PETROL FILLING STATION, CLOTHALL ROAD, BALDOCK (SG7 6PD)

RESPONSE TO HERTFORDSHIRE COUNTY COUNCIL LLFA COMMENTS, DATED 12 SEPTEMBER 2025

This Note has been prepared in response to the comments issued by Hertfordshire County Council Lead Local Flood Authority (LLFA), dated 12/09/2025, regarding the Combined Flood Risk Assessment and Drainage Strategy (FRA & DS) prepared by Civilistix, dated August 2025.

DRAWING TITLE: Proposed Private Drainage GA Plan

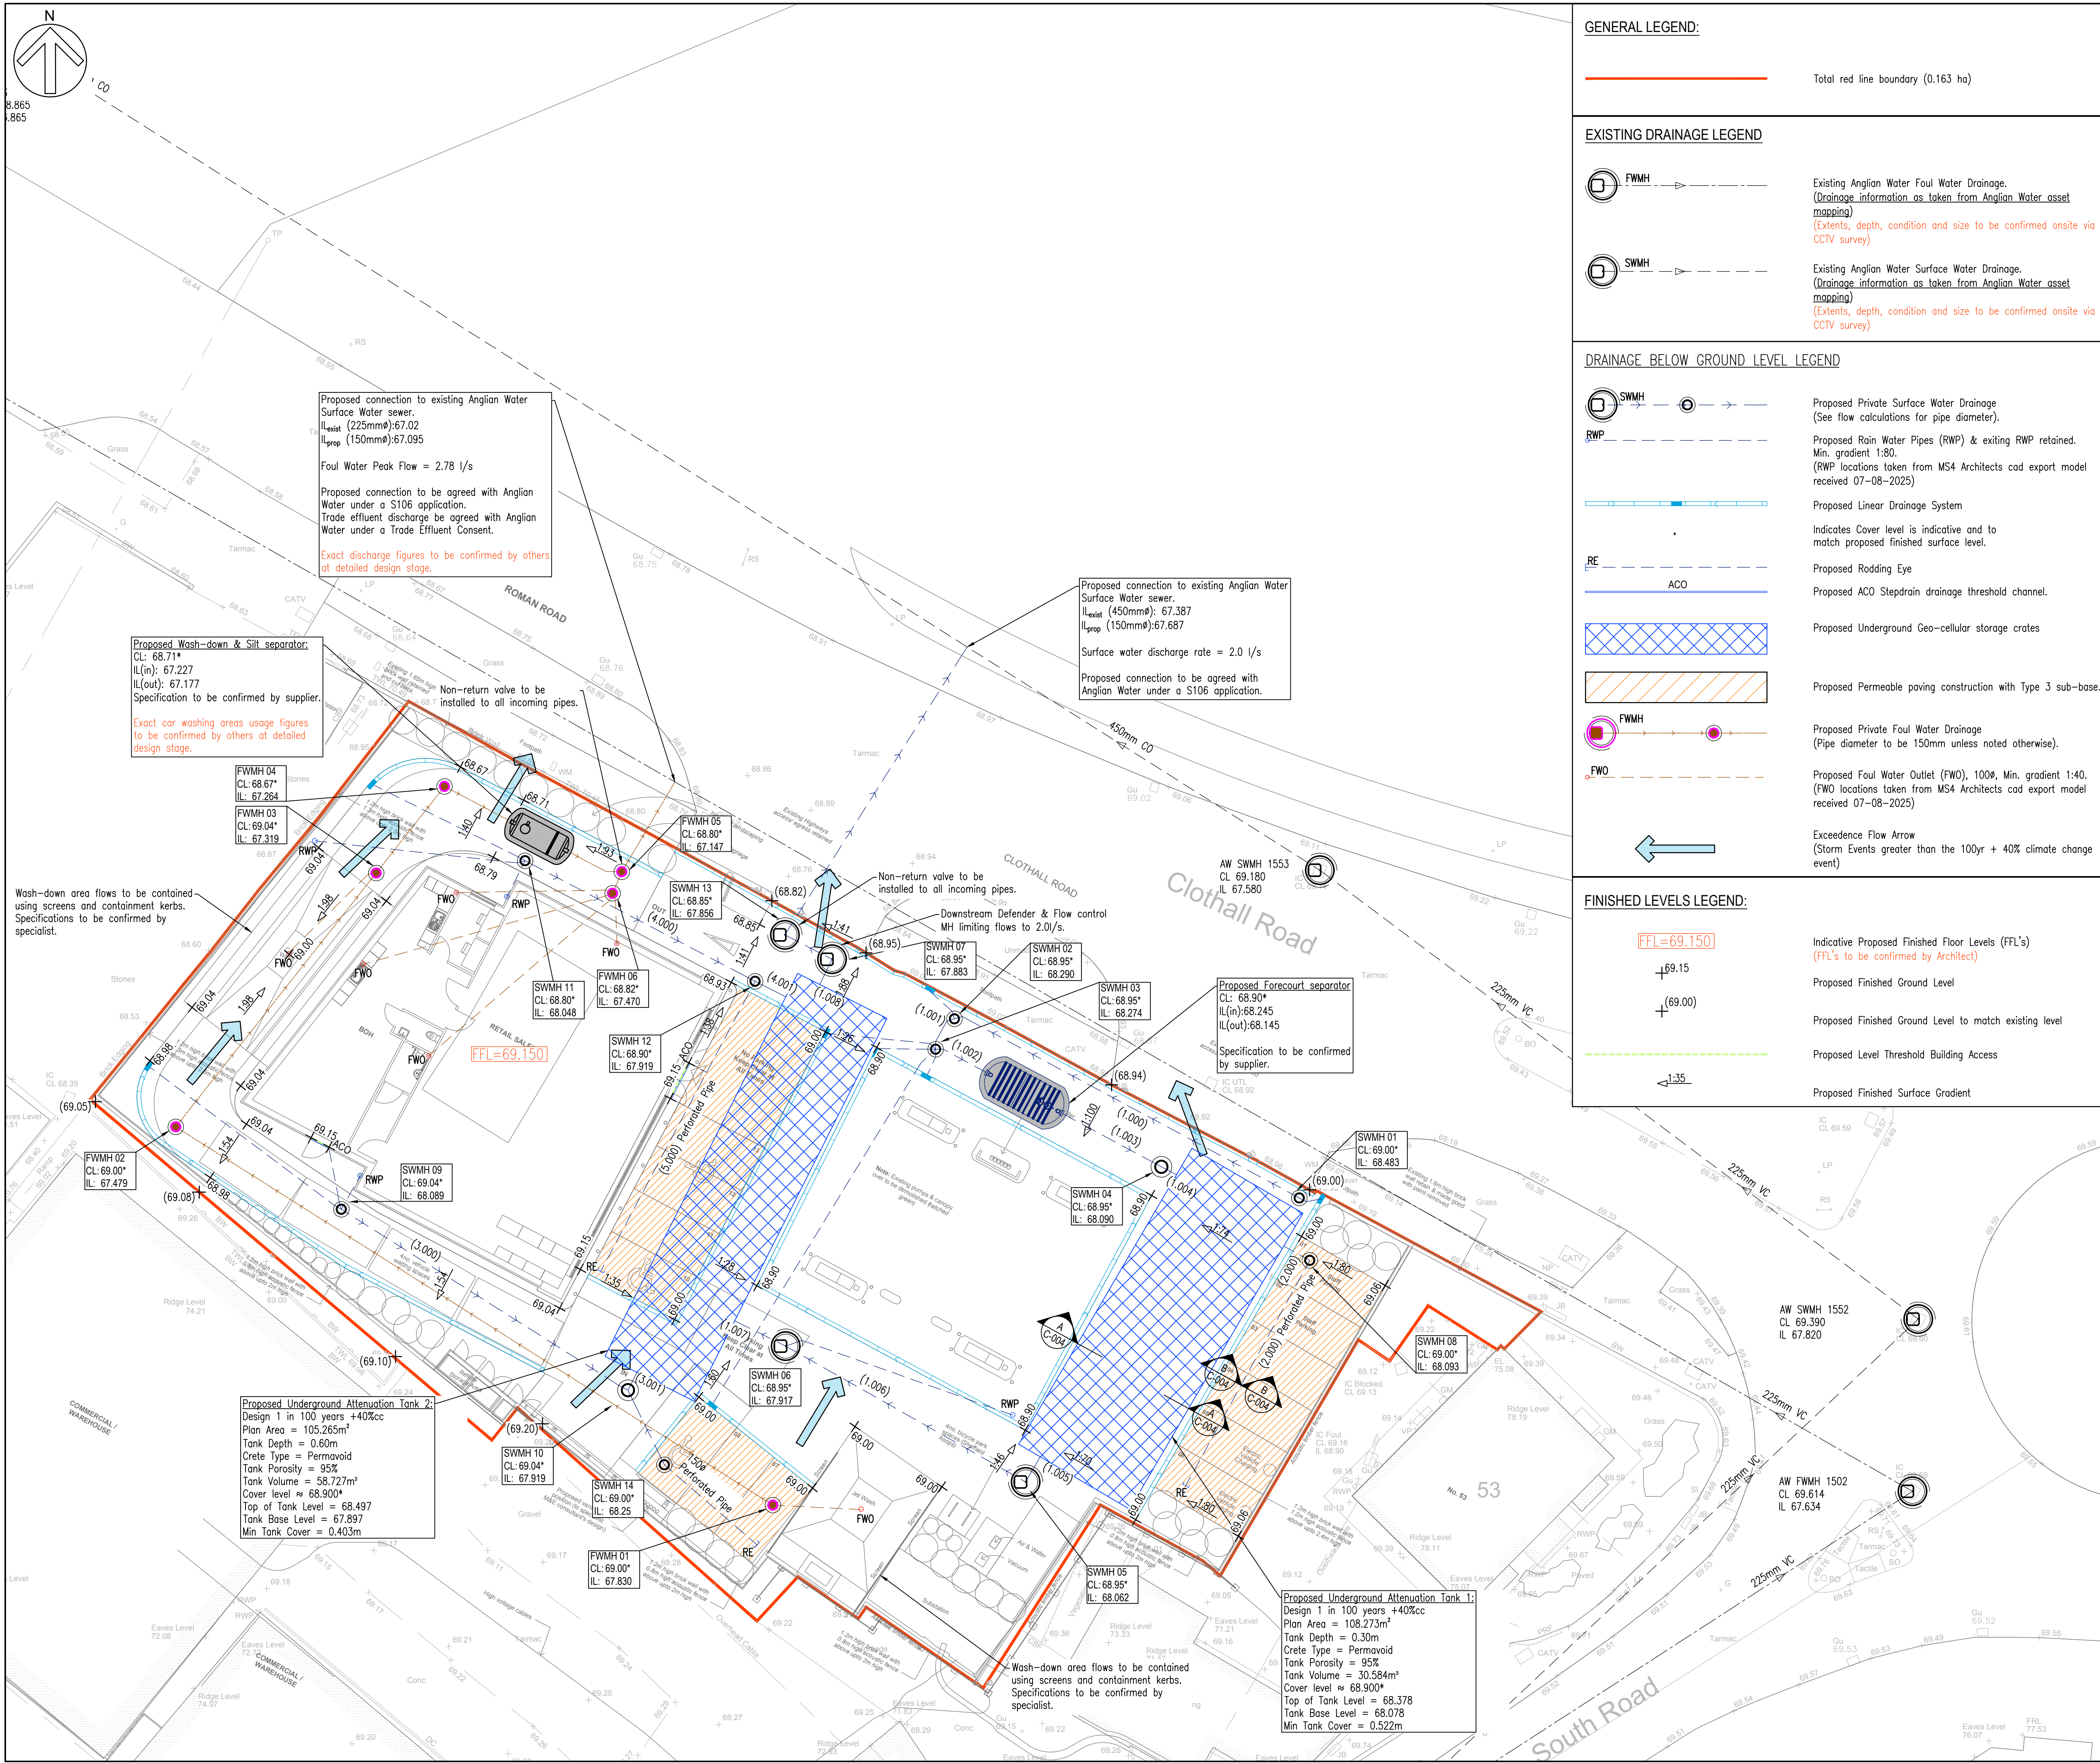
Exceedance of the design 1% AEP rainfall event plus climate change (or failure of the drainage network) must be shown on a drawing, minimising impacts to people and property. This drawing will include proposed external ground levels, finished floor levels and any designed slopes on impermeable surfaces such as car parks.

Revised drainage strategy drawing with exceedance routes is provided in **Appendix A**.

P2	10-10-2025	FR	EXCEEDENCE ROUTES ADDED	FR	DM
P1	12-08-2025	KH	PLANNING ISSUE	FR	DM
REV	DATE	BY	SUMMARY OF CHANGE	CHK	APD
